FILE P.I. # 522790-
STP00-0218-01(001)
Chatham County
GDOT District 5 - Jesup
Jimmy Deloach Parkway Extension from I-16 to SR
26/US 80

SUBJECT APPROVED REVISED CONCEPT REPORT

January 11, 2013

The revised Concept Report submitted for project STP00-0218-01(001) in Chatham County has been reviewed. As noted in the revised Concept Report, Georgia Department of Transportation (GDOT) recommends the revisions based on the recommendations of the value engineering study dated March 8-11, 2010. As a result of the information submitted, Federal Highway Administration (FHWA) has concurred with the following comments:

EXISTING (2009) ANNUAL
AVERAGE DAILY TRAFFIC (AADT)

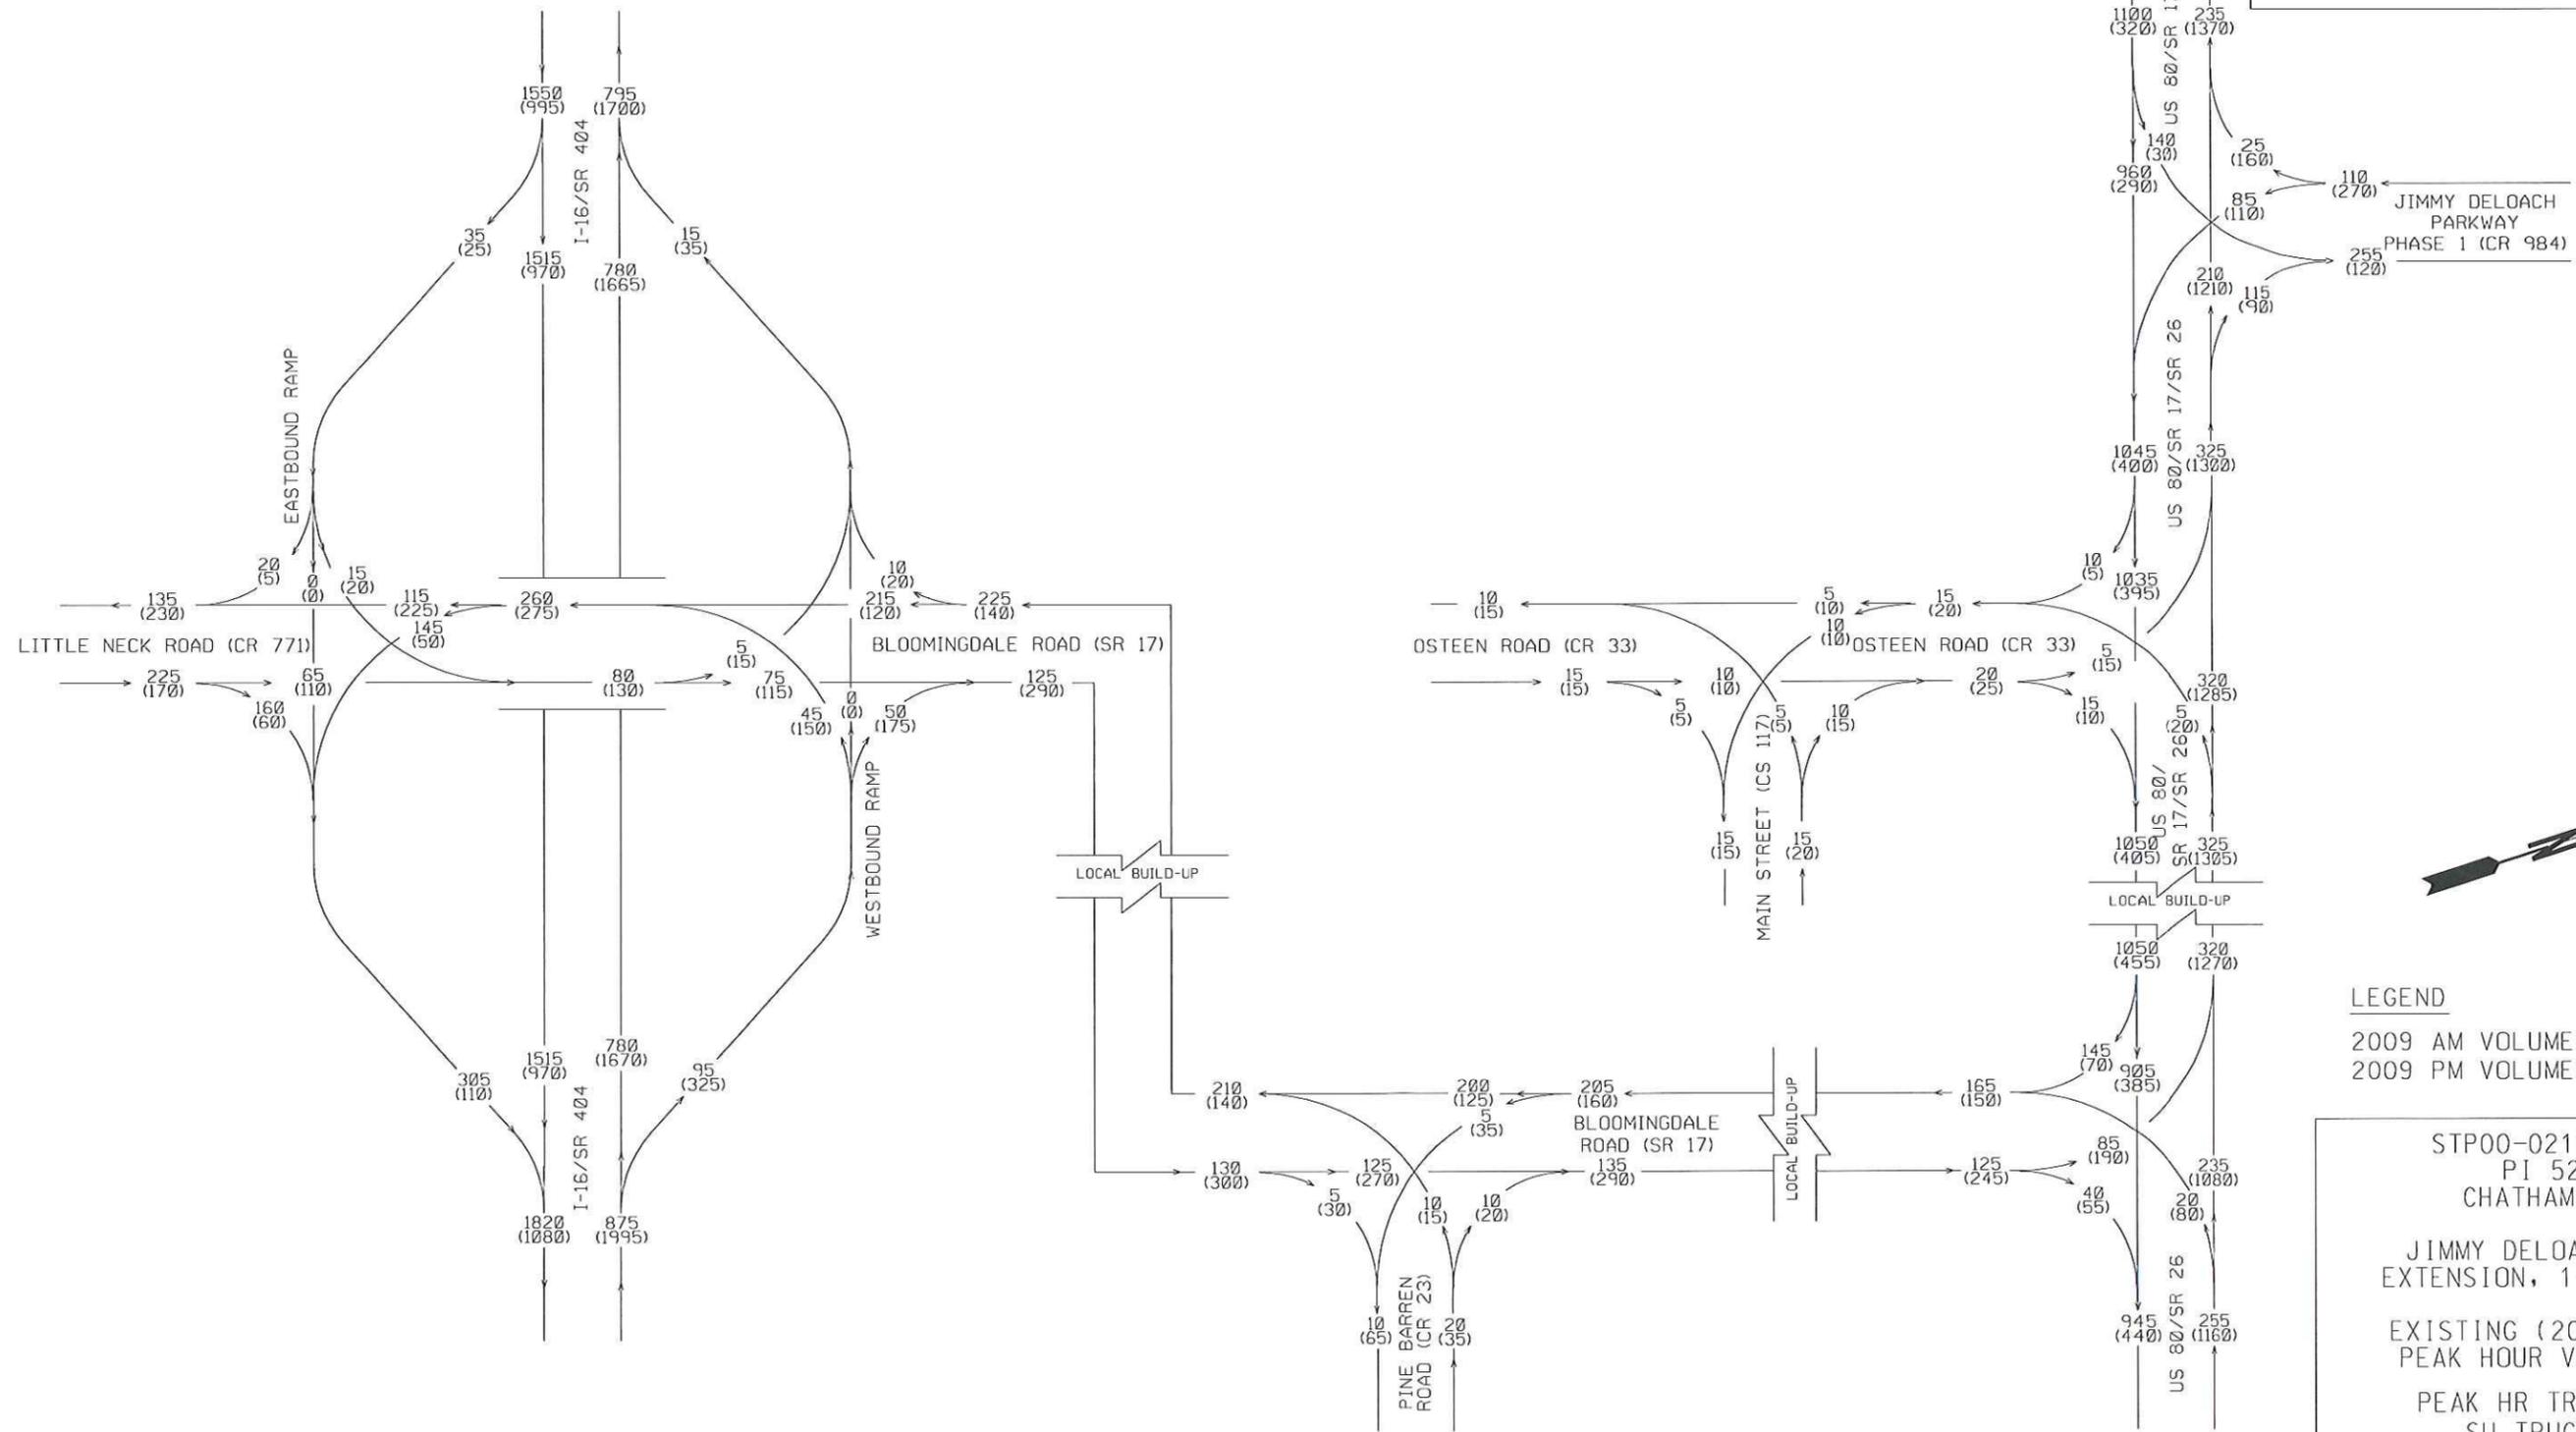
- Design Traffic: Peak Hour Trucks of 10% and 24 Hour Trucks of 15% are relatively low since the project will provide connectivity from the Georgia Port Authority's port facilities in Port Wentworth to I-16. Please verify the truck percentage will be using the facility.

TYPICAL SECTION, NO. 5
TANGENT SECTION
JIMMY DELOACH PARKWAY
135+90.00 TO 150+87.73

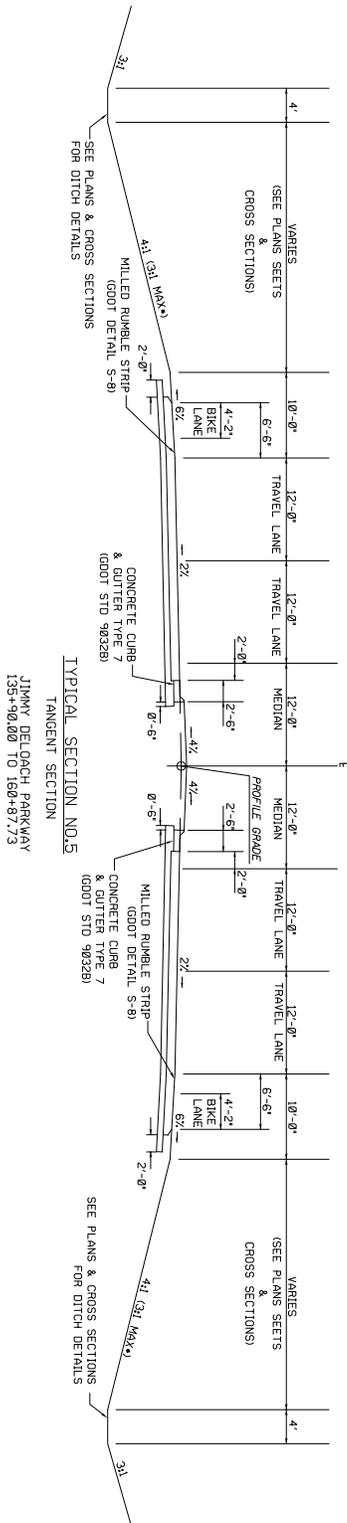
- Typical Sections No. 5 and 7: Please consider changing concrete curb and gutter Type 7 to 4" tall Type 1 (GDOT Standard 9032B). Curbed sections are generally restricted to design speeds of 45 mph or less. Where curb is needed for drainage, the use of curb no higher than 4-in with a mountable profile is recommended.
